**Pacific Gas and
Electric Company**

PG&E Letter DCL-00-030

Docket No. 50-275, OL-DPR-80
Docket No. 50-323, OL-DPR-82
Diablo Canyon Units 1 and 2
Response to NRC Reactor Systems Branch Questions Regarding WCAP-14707

**Responses to NRC Reactor Systems Branch Questions Regarding
WCAP-14707**

Figure 1

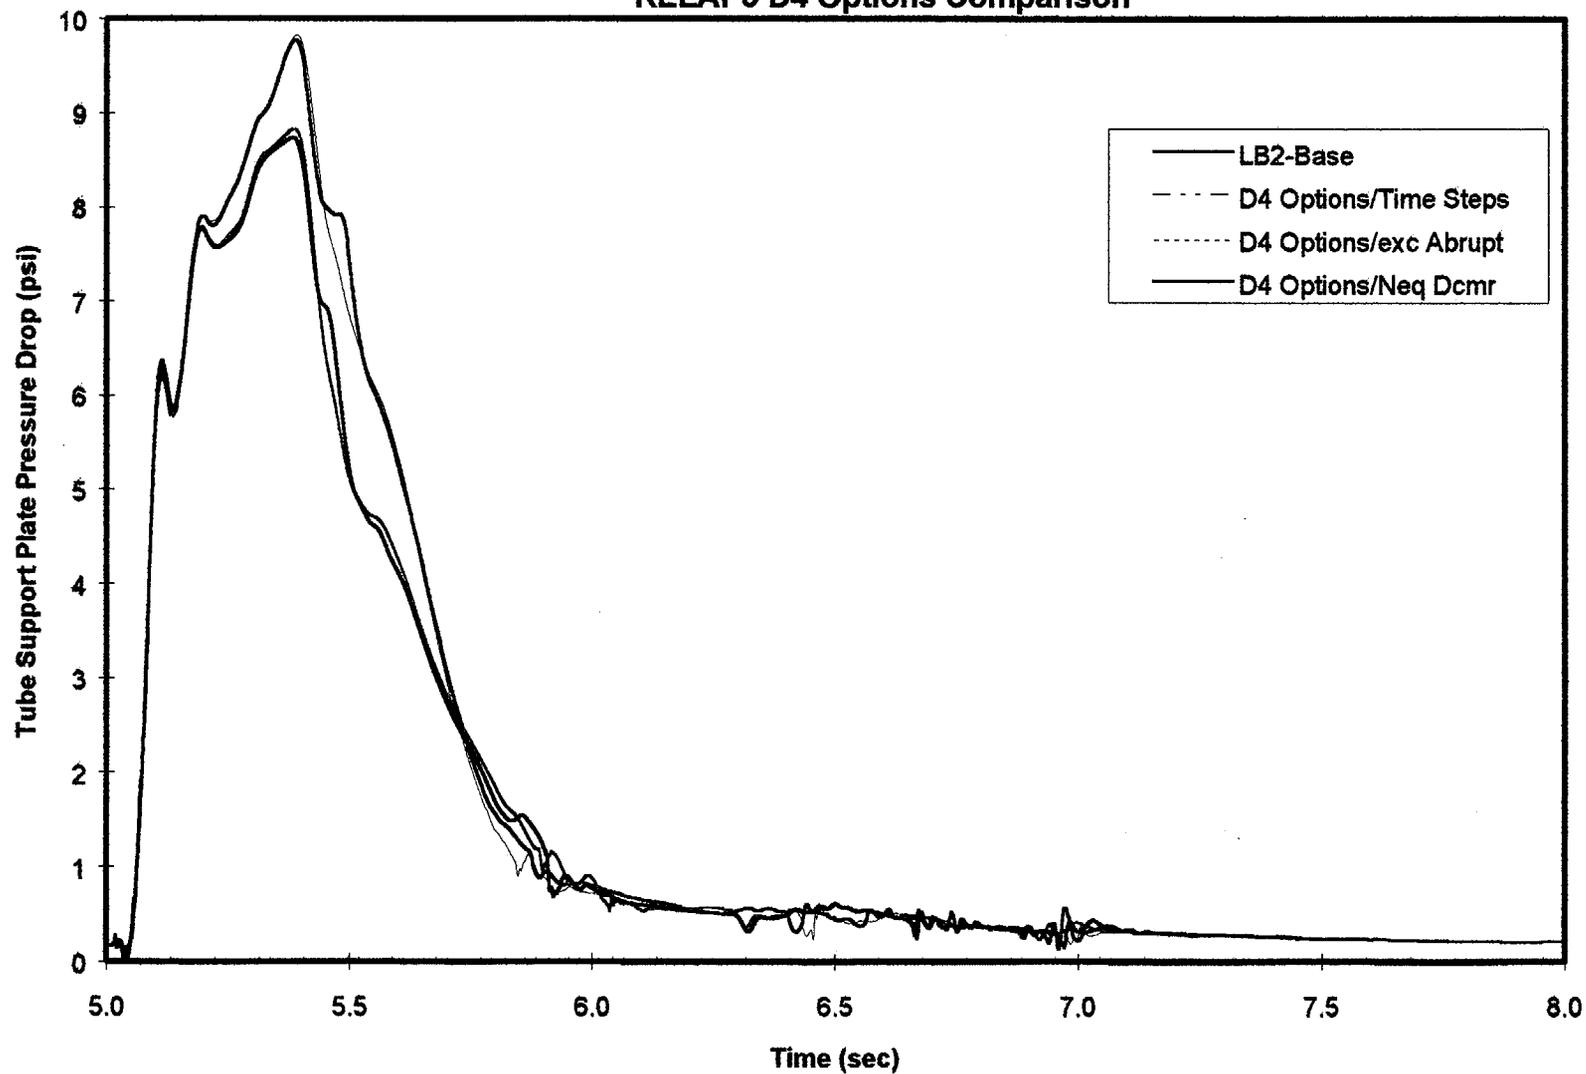
Please provide a description of the dominant physical processes, the needed model capabilities, how the chosen tool meets these needs, and the inherent uncertainties in the chosen model.

Figure 1 of this enclosure compares the original Model 51 pressure drop across the number seven tube support plate, with the results obtained with the revised model which implements the ComEd model options which were used for the D4 SG analysis. The results indicate that the characteristic response is not significantly changed, but the peak pressure is actually reduced for the D4 options case. In order to identify the source for the reduced peak pressure results, two additional sensitivity studies were performed. Since the ComEd analysis used longer time step intervals as summarized in Table 3 of this enclosure, the PG&E Model 51 SG was rerun using these time step values. The results plotted on Figure 1 show that this revision had an insignificant effect on the results. This is expected since the ComEd time step sensitivities in Reference 6 demonstrated that the time step size was appropriately small for the D4 analysis.

A second additional sensitivity case was performed using all of the D4 modeling options except for the restoration of the abrupt area change option, which was used in the original PG&E model as summarized in Table 2 of this enclosure. The abrupt area change is a RELAP5 option to model junctions with a significant change in cross section geometry such as valves and flow orifices. If not enabled, then RELAP5 calculates the pressure drop across the junction based on smooth geometry transition correlations. These results are also plotted on Figure 1 of this enclosure, and demonstrate that the D4 case with the abrupt area change option generated essentially the same peak pressure response as the original PG&E Model 51 SG analysis.

These results demonstrate that the SGTSP loads calculated by the original PG&E Model 51 SG RELAP5 model are not significantly affected by the slight differences in modeling options that were used in the Reference 6 analysis. In addition, the PG&E model predicts conservatively larger pressure drops with respect to the same conditions evaluated by the NRC approved ComEd model for the D4 SG.
